**ADDENDUM  
NO. 3**

**September 30, 2025**

**VALE FACILITY ADDITION/RENOVATIONS AND  
MAINTENANCE/IT FACILITY PROJECTS**

**Addendum Three (AD.03)** to the drawings and specifications prepared by Gibraltar Design for **Valparaiso Vale Facility Addition/Renovations and Maintenance/It Facility and Related Work** for Valparaiso Community Schools, Valparaiso, Indiana.

GIBRALTAR DESIGN SHEET  
**C-103**

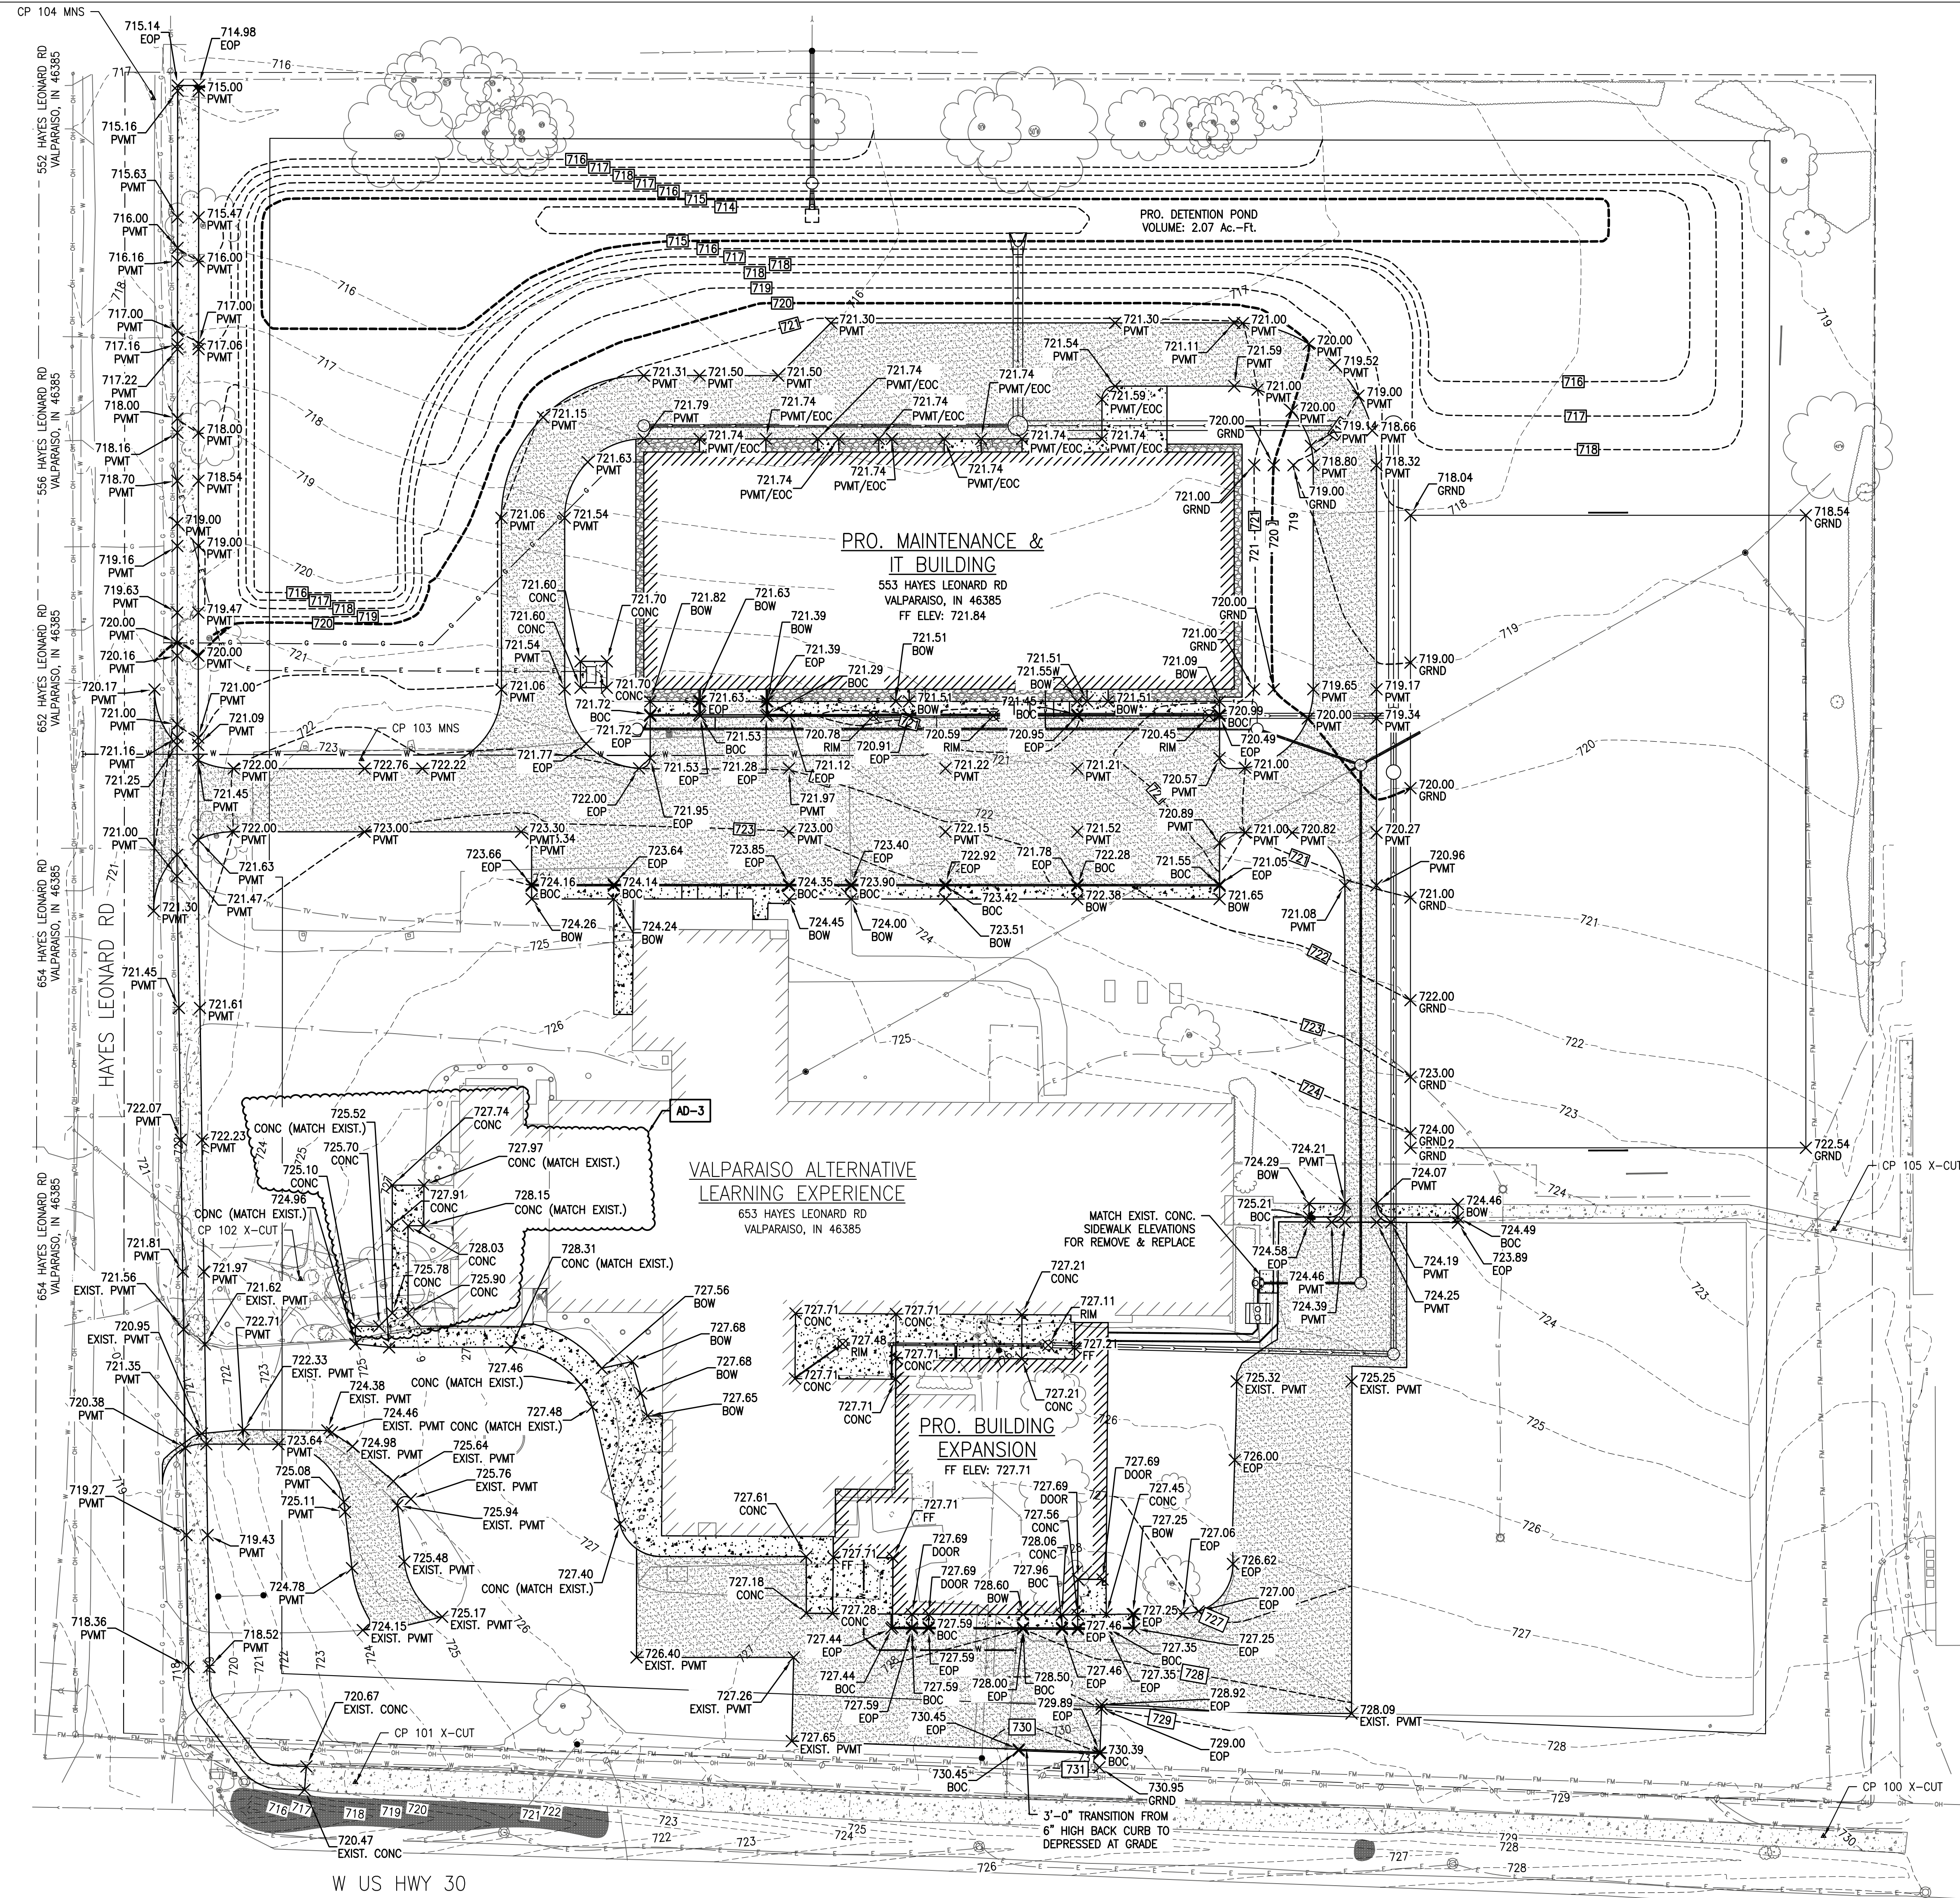
1. Added proposed and tie-in grades for the concrete sidewalk that leads up to the stairs of the West entrance for VALE.

**AD-3 REVISIONS:**  
1. ADDED PROPOSED AND TIE-IN GRADES FOR THE CONCRETE SIDEWALK THAT LEADS UP TO THE STAIRS OF THE WEST ENTRANCE.

SHEET  
**C-105**

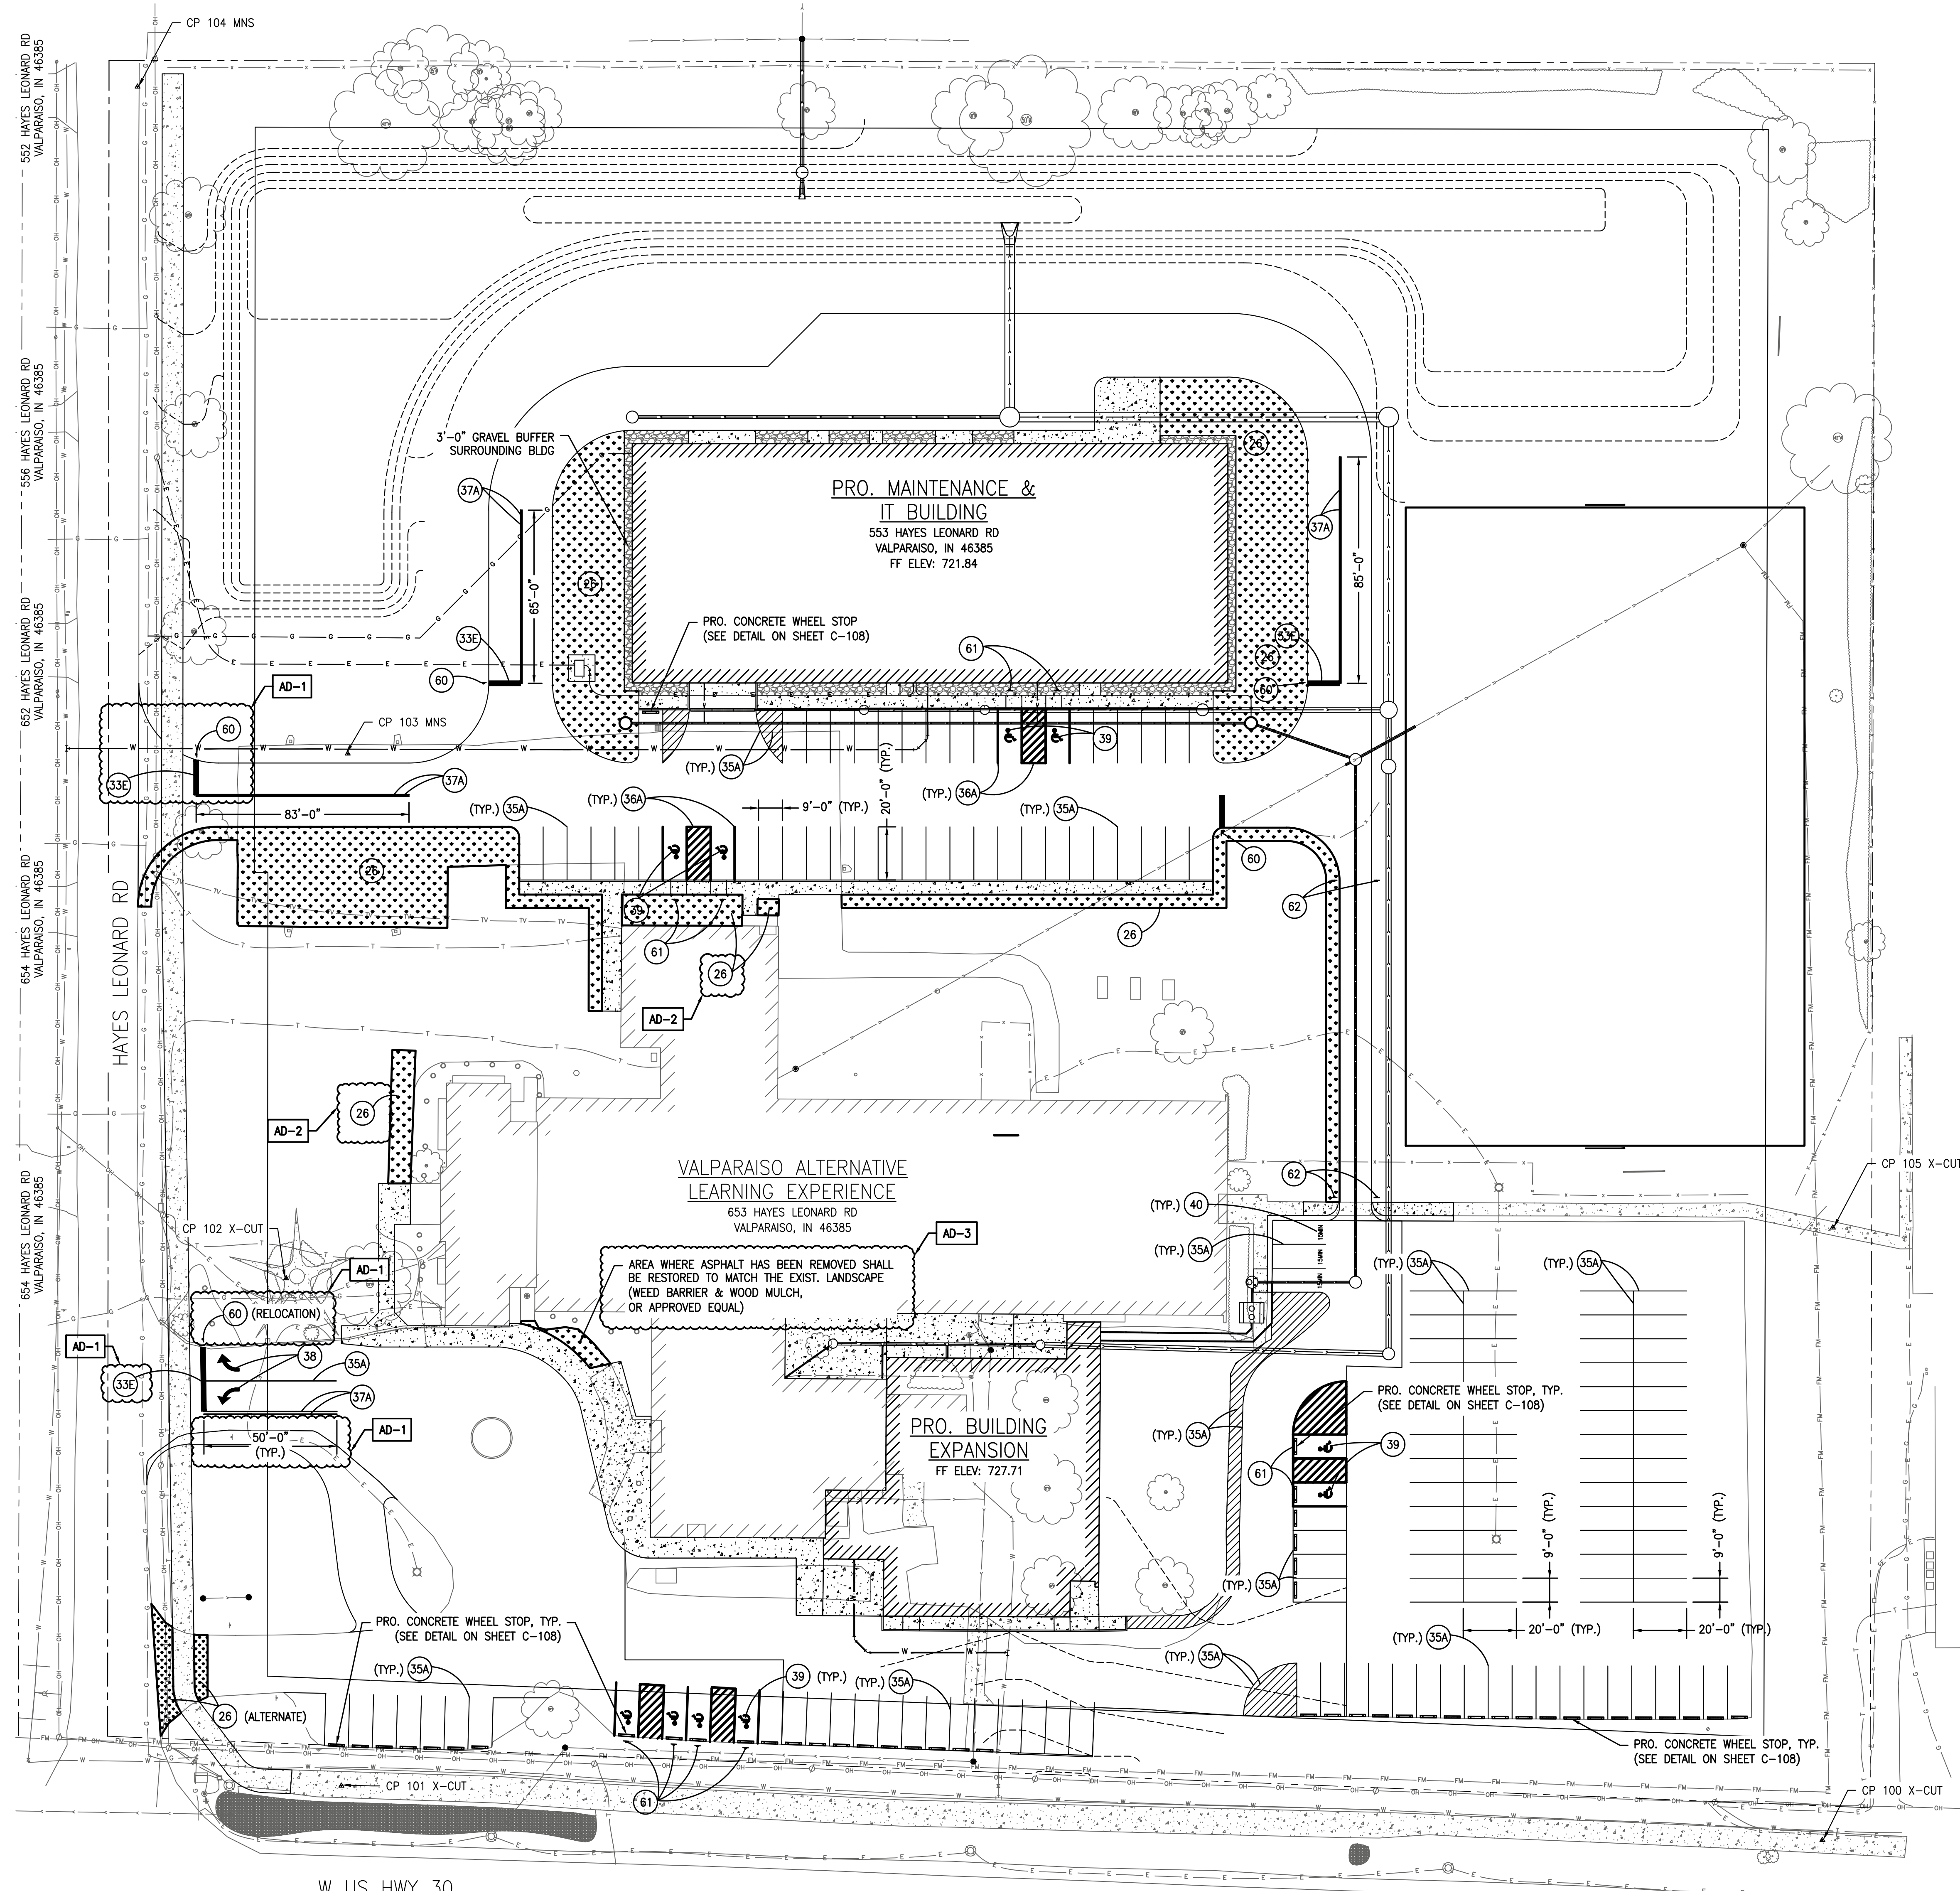
1. Added note on how to restore removed asphalt area near the West entrance of VALE.

- AD-1 REVISIONS:**
- RELOCATED THE STOP BARS TO BE 4'-0" EAST OF THE MULTI-USE PATH.
  - RELOCATED THE STOP SIGNS TO ALIGN WITH THE RELOCATED STOP BARS.
  - LENGTHENED THE 4" DOUBLE YELLOW LINES TO 50'-0".
- AD-2 REVISIONS:**
- ADDED NOTES TO INDICATE DEMOLISHED AREAS TO BE RESTORED WITH TOPSOIL & SEEDING.
  - ADDED "ADA PARKING SPACE & AISLE" DETAIL.
- AD-3 REVISIONS:**
- ADDED NOTE ON HOW TO RESTORE REMOVED ASPHALT AREA NEAR THE WEST ENTRANCE.
